STAFF REPORT: 4/14/2021 MEETING

ADDRESS: 1627 (1627-1639) LEVERETTE

HISTORIC DISTRICT: CORKTOWN

SCOPE: ERECT NEW CARPORTS; REHABILITATE BUILDING

**Front Window
 Corrections**

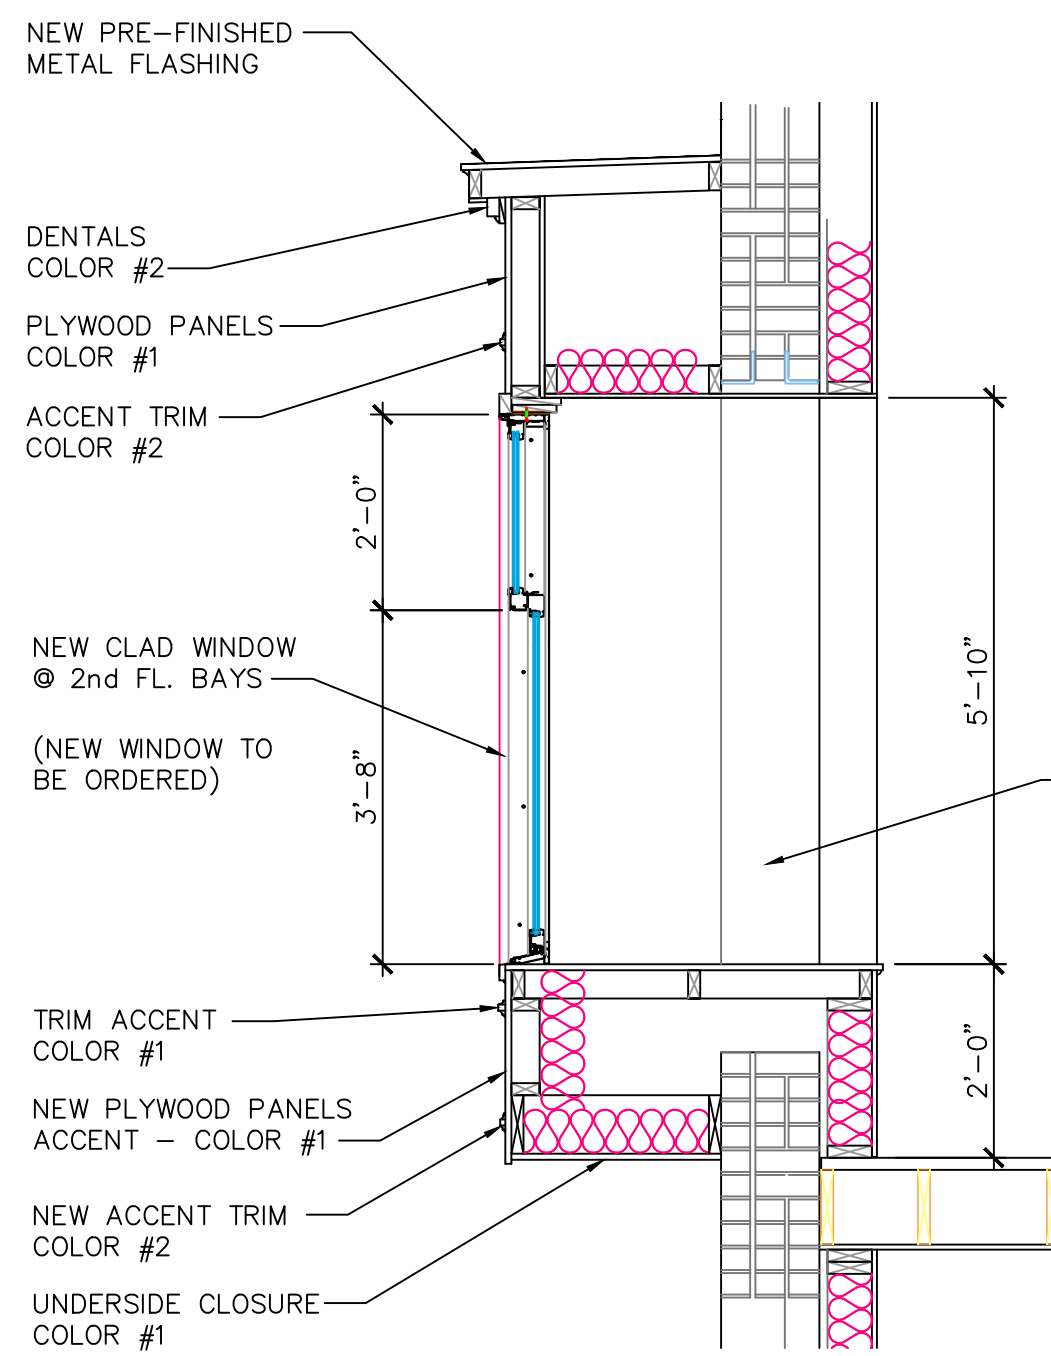
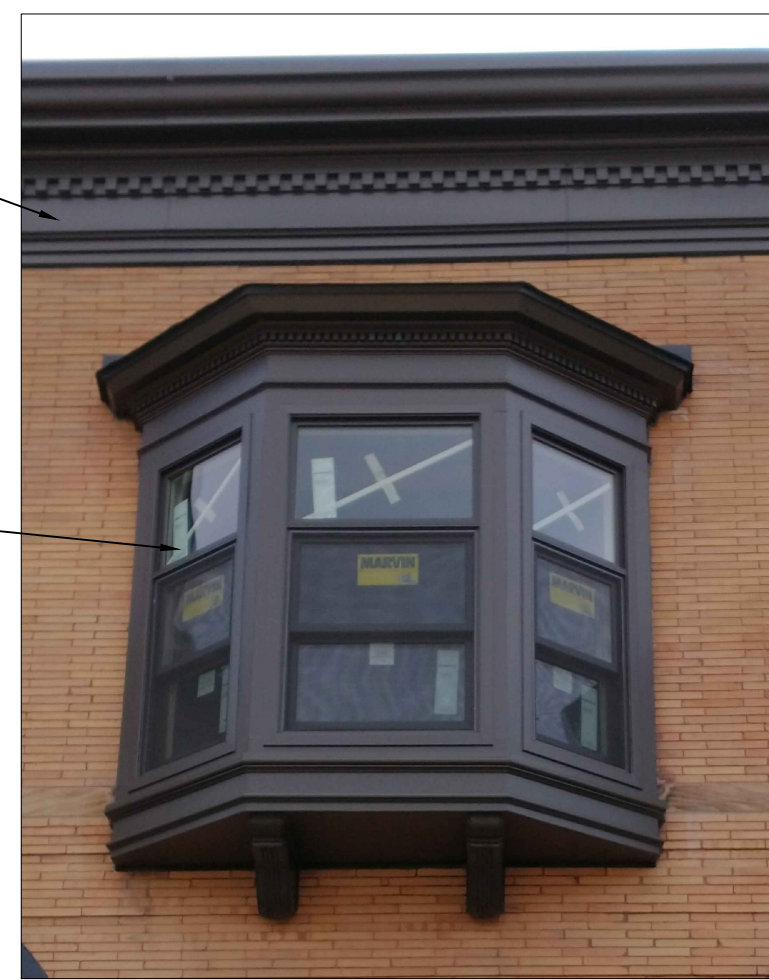
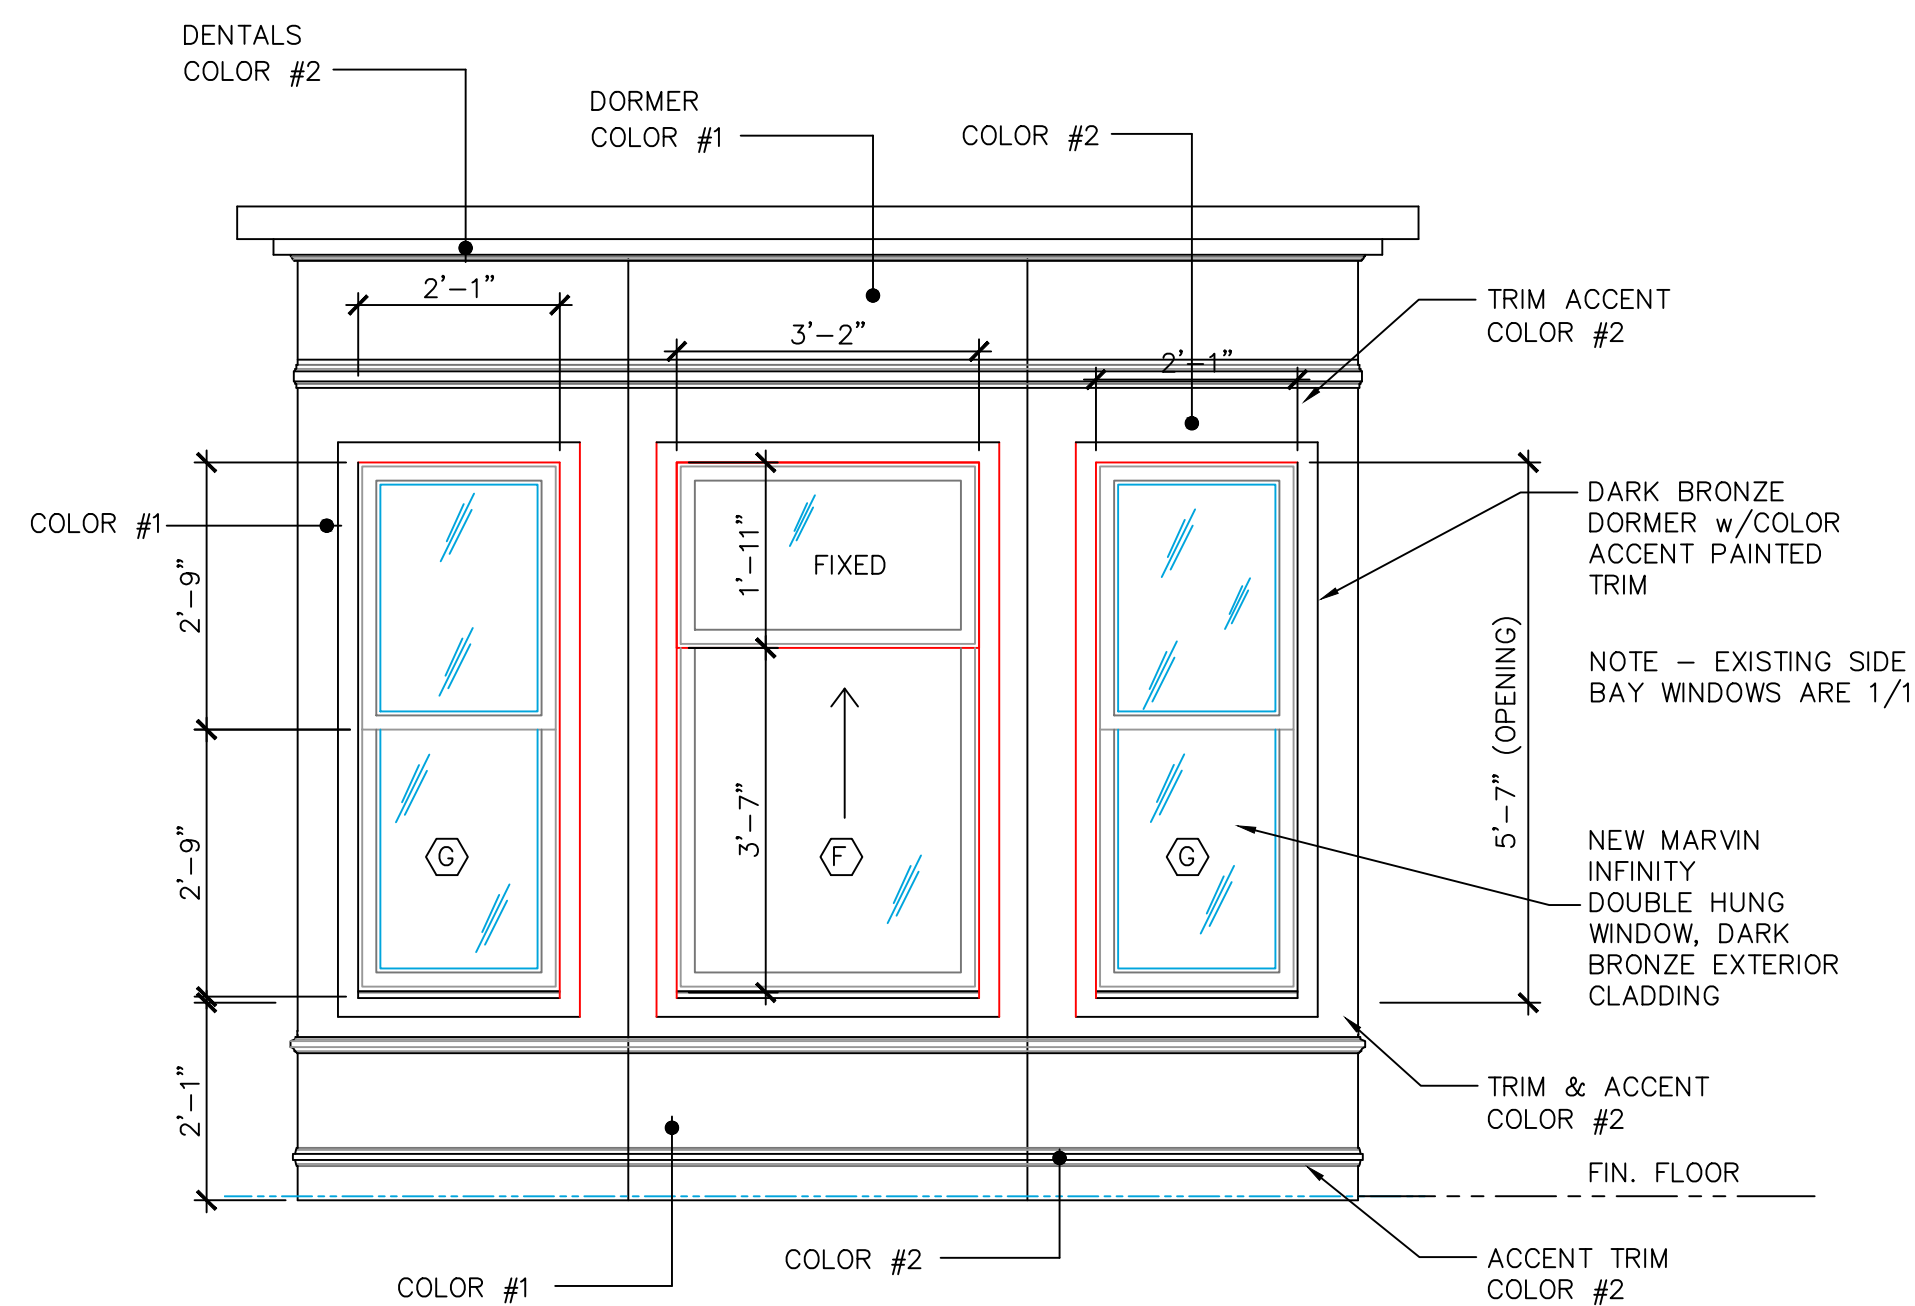
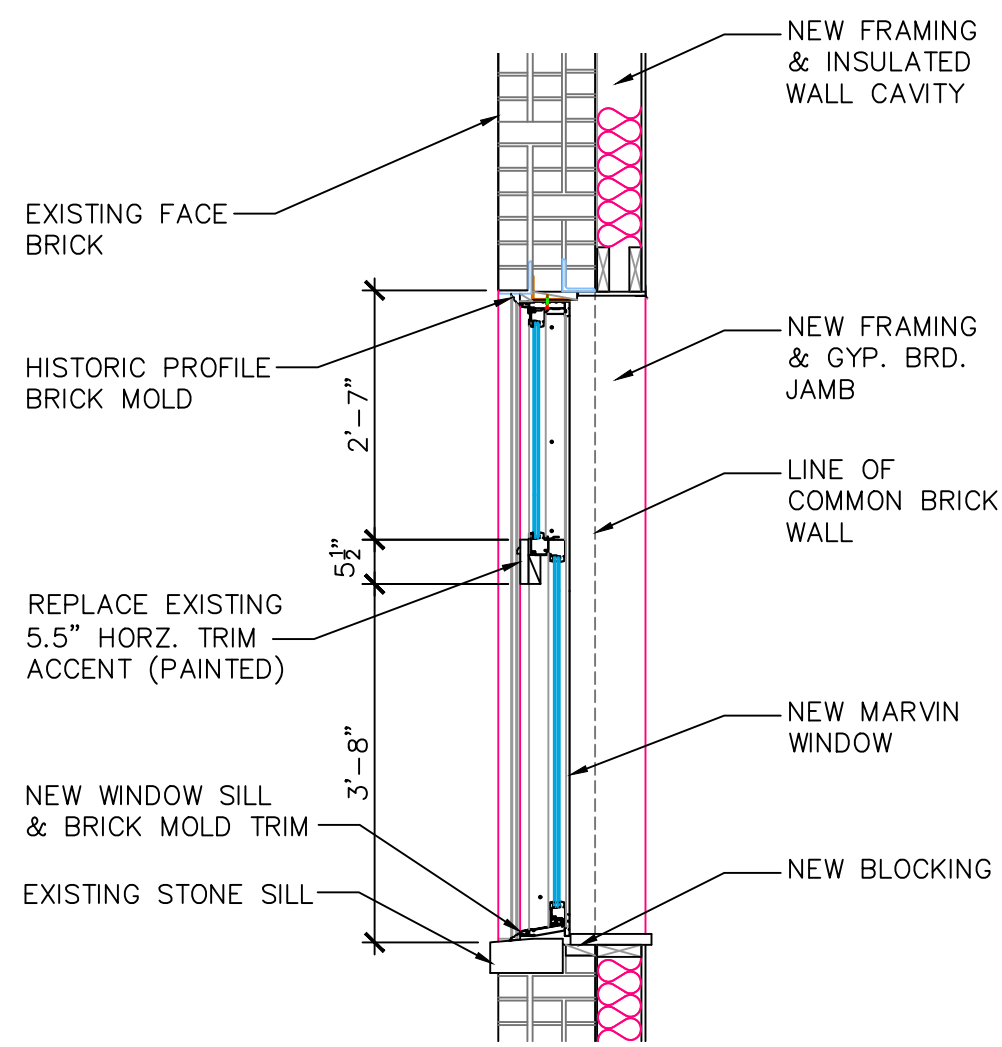
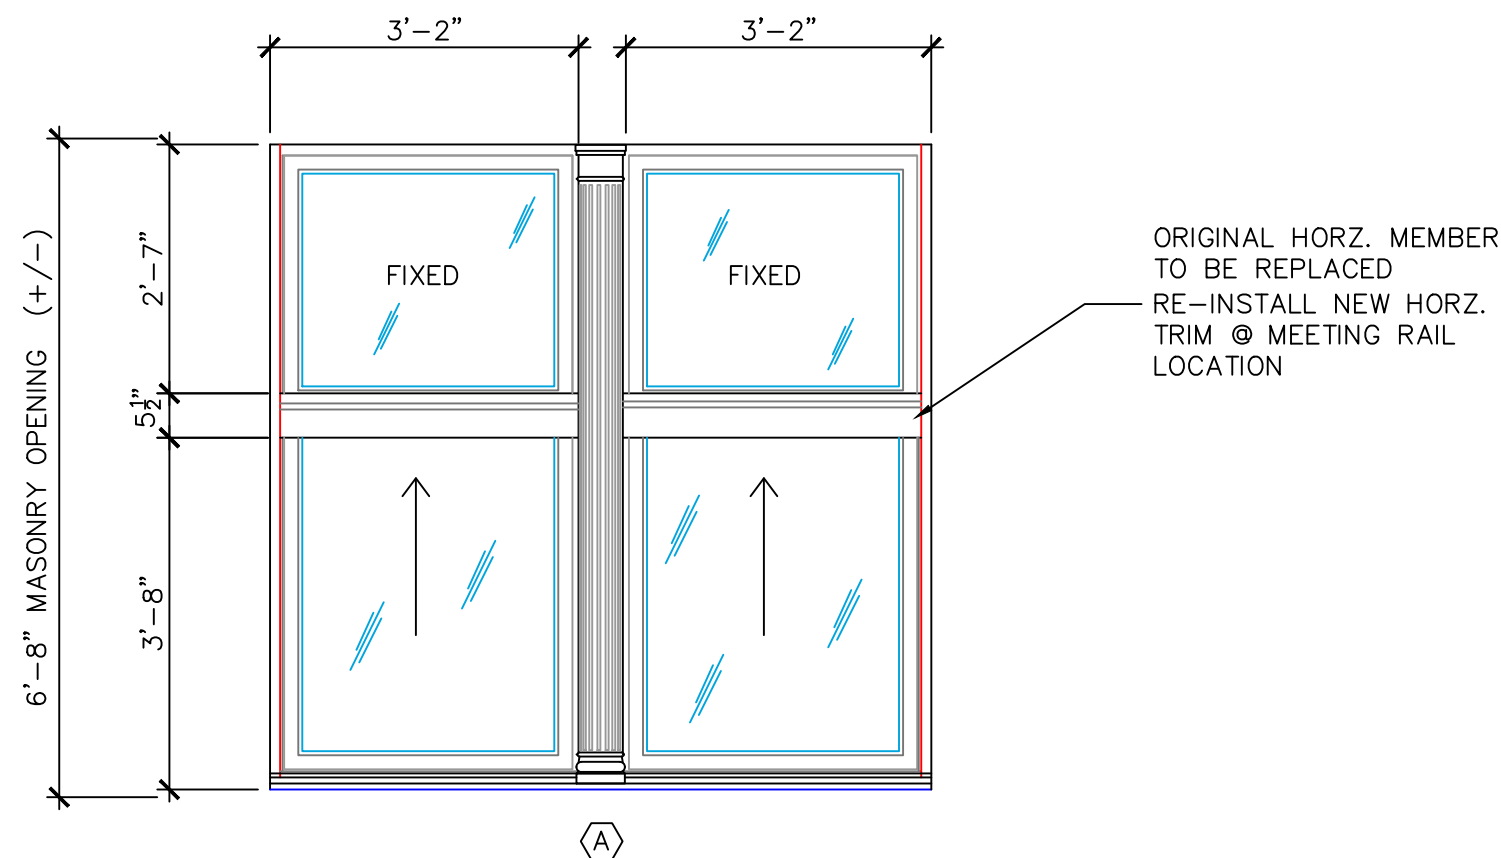
- At front elevation, second story bay windows – original sash were wood, 1/1, double-hung units. In 2020, these windows were replaced with wood, 1/1, double-hung units, each which is topped with a fixed wood transom window without approval. With the current submission, the applicant is proposing to REMOVE all

existing windows and replace with new 1/1 aluminum-clad wood units to match the original

- At front elevation, first-story windows – each opening originally included a set of paired fixed wood windows which were topped with fixed wood transom. The sash were set into wood trim. A fluted wood pilaster served as each window opening’s mullion. In 2020, these windows were replaced with 1/1, double-hung, wood-sash units with aluminum-clad trim. The original fluted wood pilaster mullions appear to have been retained. With the current the applicant is proposing to **RETAIN** the existing aluminum-clad wood windows. However, the new proposal includes the addition of wood trim at each window’s meeting rail to match the original

- While the new windows added in 2020 without approval are wood, they did not match the operation of the original windows at the front elevation. The current application proposes to mitigate this situation by completely replacing the windows at the second story bays with new windows to match the original in operation. The current application will also add a trim piece at the meeting rail at all first-story windows in order to better replicate the original windows.

SECOND LEVEL
 REMOVE UN-APPROVED BAY WINDOWS & INSTALL NEW WINDOW MATCHING PROPORTIONS OF EXISTING BAY WINDOW OPENINGS; REPAINT TRIM ACCENT (COLOR #2) (BASE COLOR TO REMAIN THE SAME)

FIRST LEVEL
 RE-INSTALL HORIZONTAL TRIM MEMBER AT MEETING RAIL - (RE-INSTALL HORIZONTAL TRIM AT LOCATION OF REMOVED WINDOW HORZ. MEMBER)
 APPLY NEW TRIM COLOR ACCENT AS INDICATED ON PICTURE OF ENTRY
